SUNDRY NOTICES AND REPORTS ON WELLS

8. Well Name and No.  
Federal 23#7H

OXY USA Inc. - Proposed  
Federal 23 #7H  
API No. 30-015-39436

**Temporary Abandonment of Wells on Federal Lands**  
**Conditions of Approval**

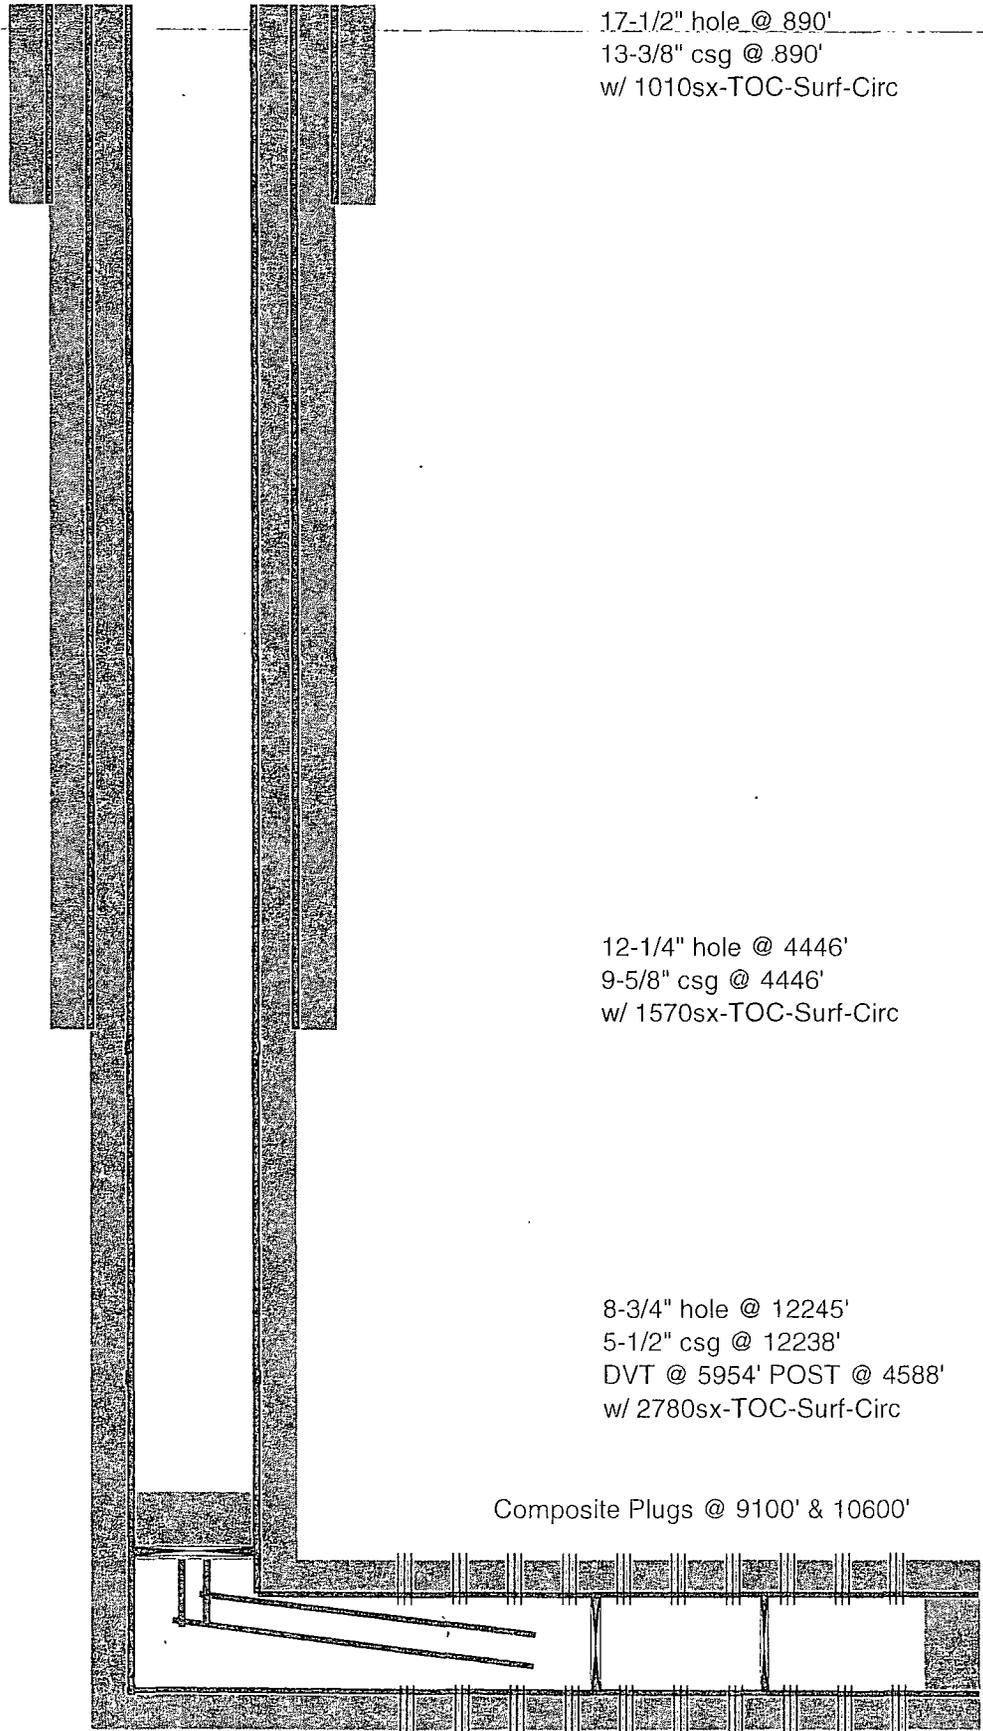
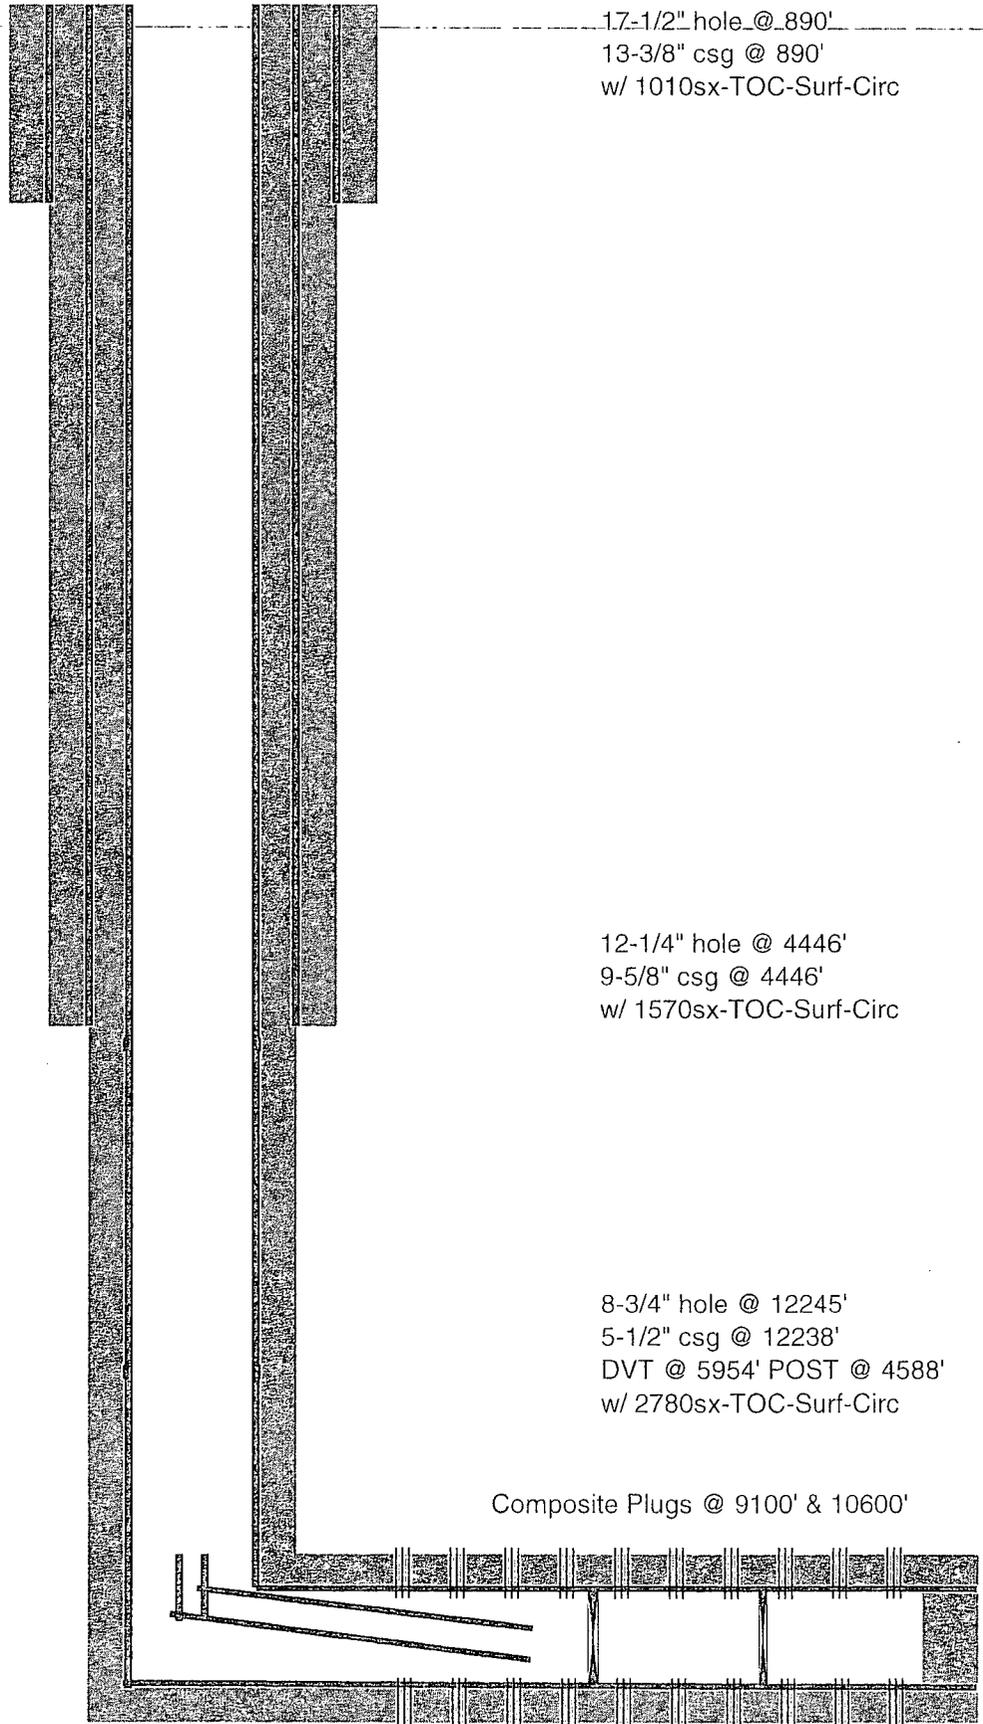
- a. A bridge plug or packer must be installed as close to 50 feet above any open perforations or open hole as possible. If a cement plug is used, the top of the cement must be verified by tagging.

- b. The wellbore must be filled with corrosion inhibited fluid and pressure tested to 500 psi. The casing shall be capable of holding this pressure for at least 30 minutes with less than 10% (50 psi) bleed off for oil and gas wells. For injection wells maximum bleed off is 5% (25 psi) within 30 minutes, outside Potash area. For all injection wells within the Potash area, any bleed off will require further review.

- c. All downhole production/injection equipment (tubing, rods, etc.) shall be removed from the casing if they are not isolated by a packer.
  - d. A bradenhead test must be conducted. If the test indicates a problem exists, a remedial plan and time frame for remediation shall be submitted within ninety (90) days of the test.

**Well Name: Federal 23 #7H Submit Subsequent Report and well bore diagram with all Perforations and CIBP with tops of cement. Well may be approved to be TA for a period of six (6) months after successful MIT and subsequent report is**
